MAP OF WATER RIGHTS TRANSFER

Situated in
Sections 13 and 18, Township 40 South
Ranges 7 and 8 West, Willamette Meridian
Josephine County, Oregon
For

Wayne O. and Nancy K. Dollarhide
3199 Helms Road
Grants Pass, Oregon 97527
April 27, 2004

T-9724

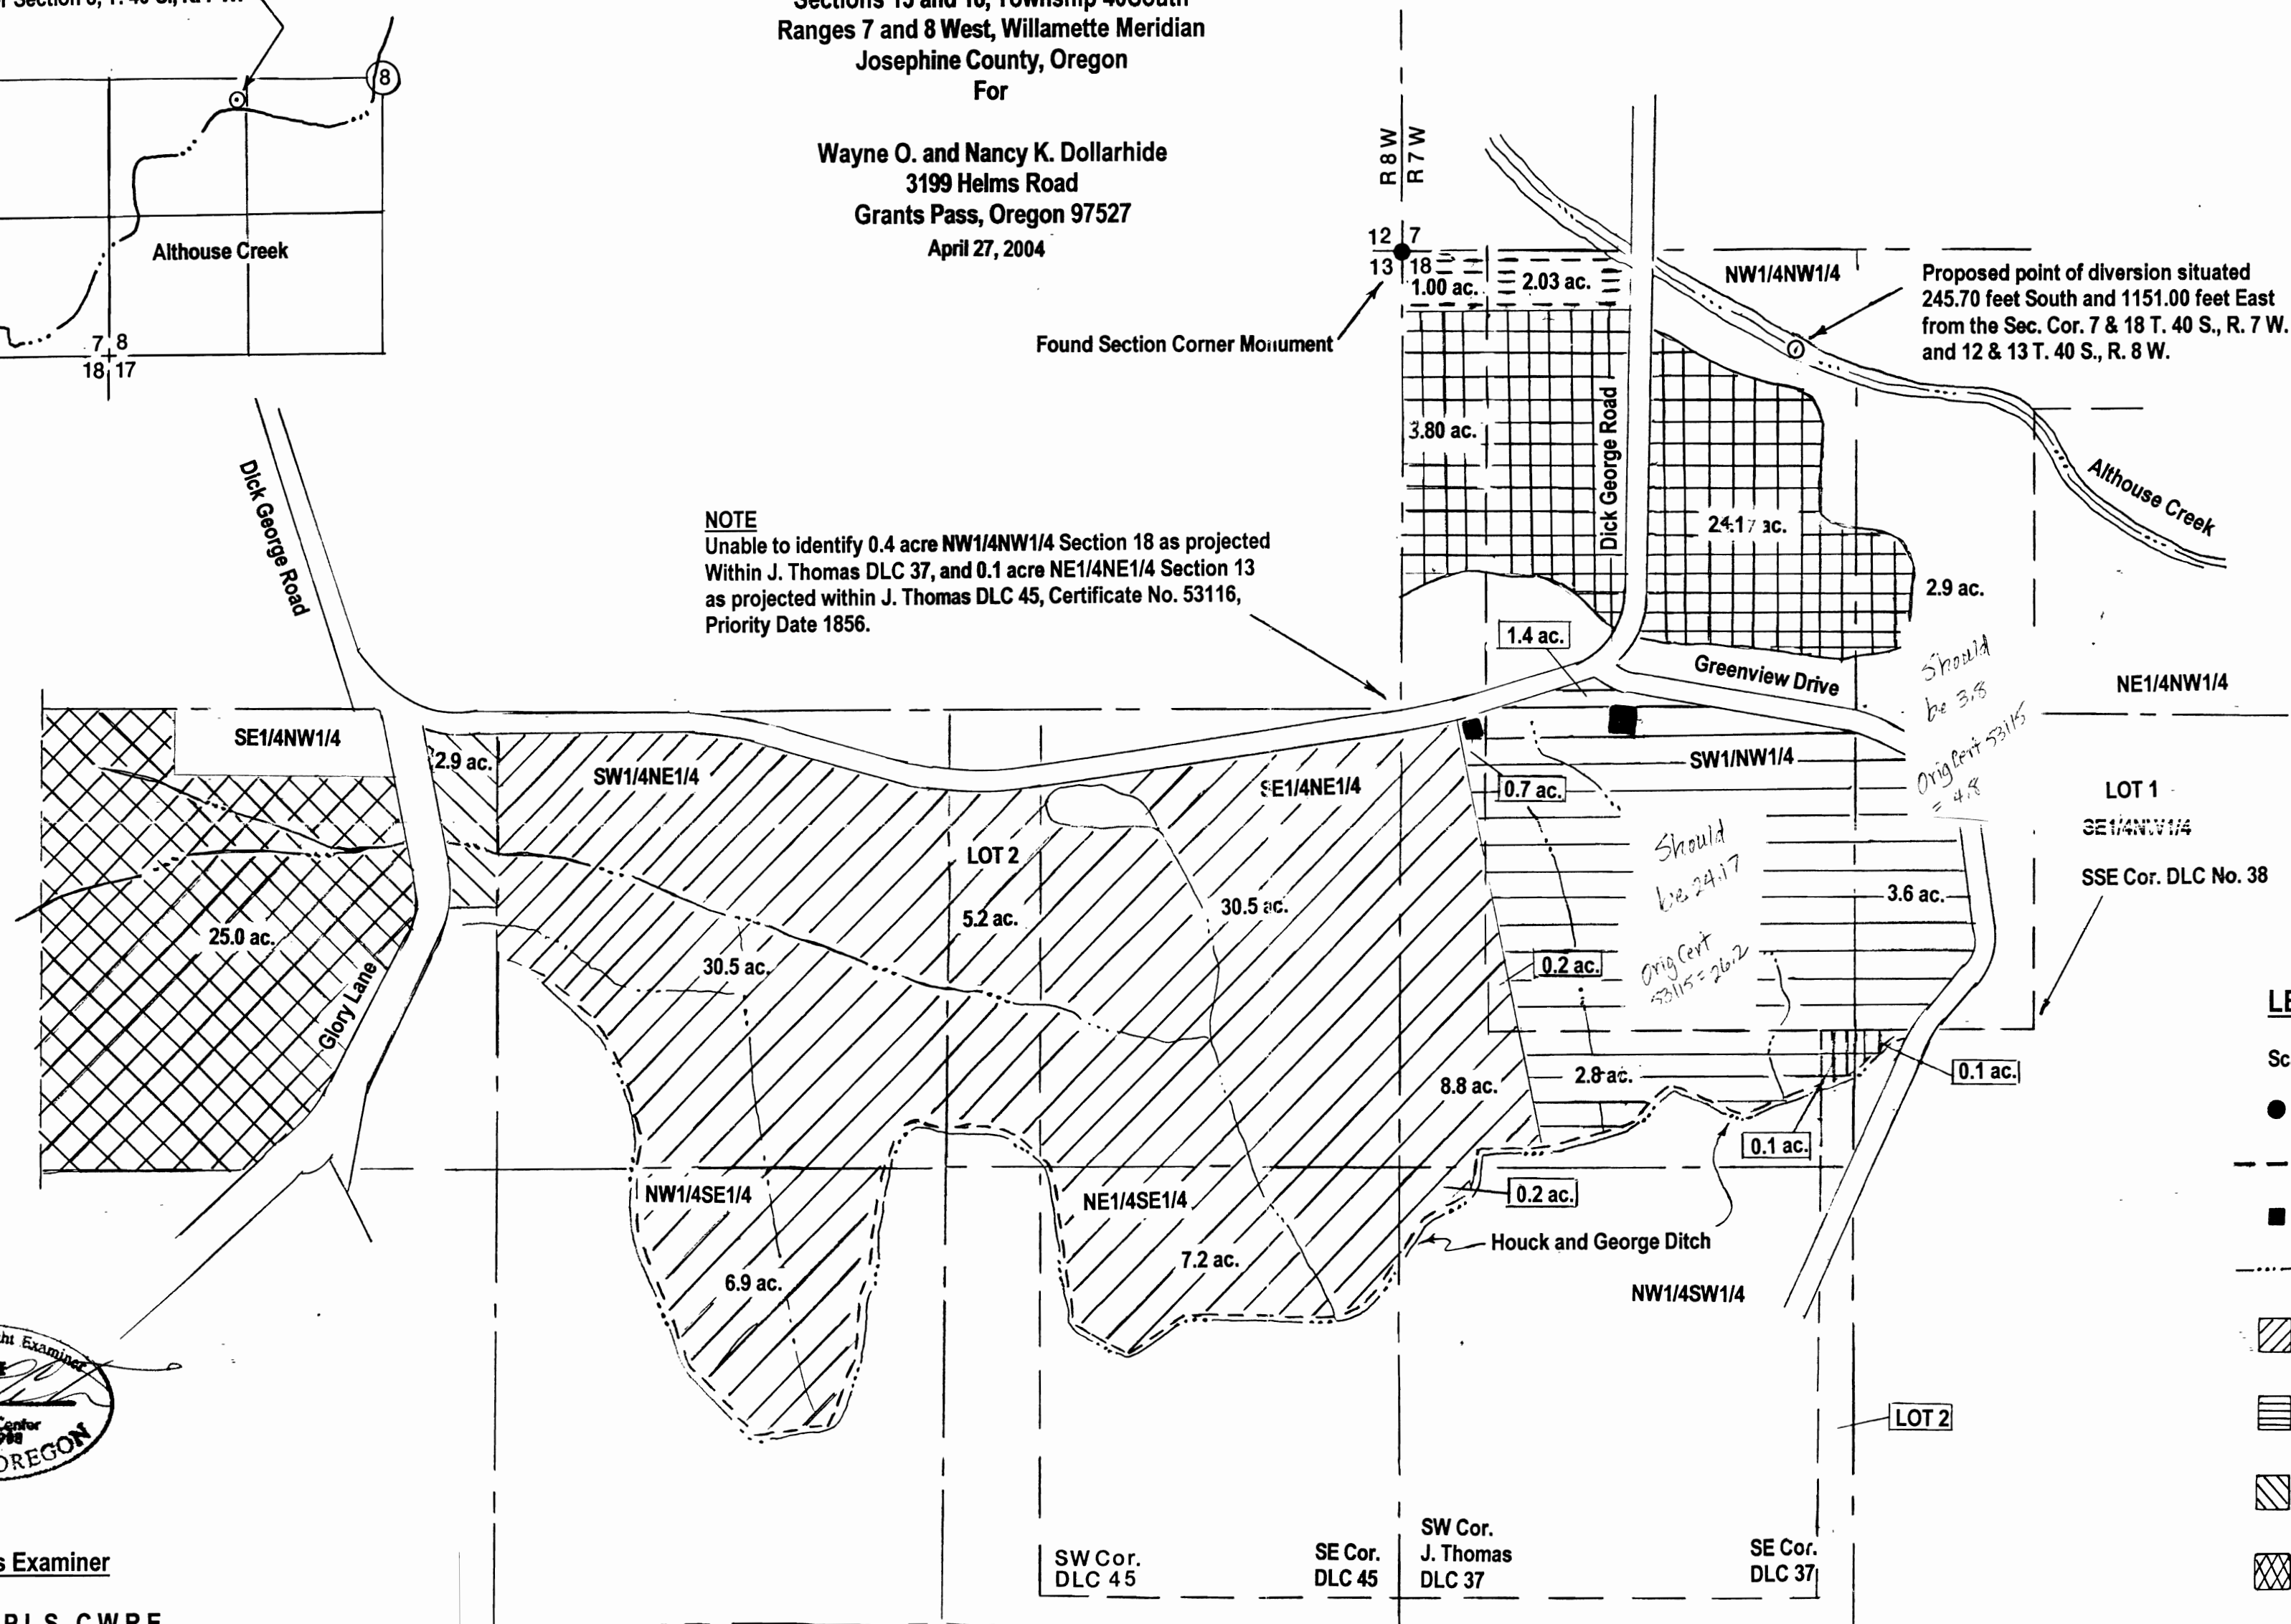
*Should be 3.8
Orig cert 53116 = 4.8*

*Should be 24.17
Orig cert 53116 = 26.2*

*On Nov 29, 2004 Harold L. Center C.W.R.E. wrote a letter agreeing with changes made on map. Per his directions changes were made.
2-15-05
VLC*
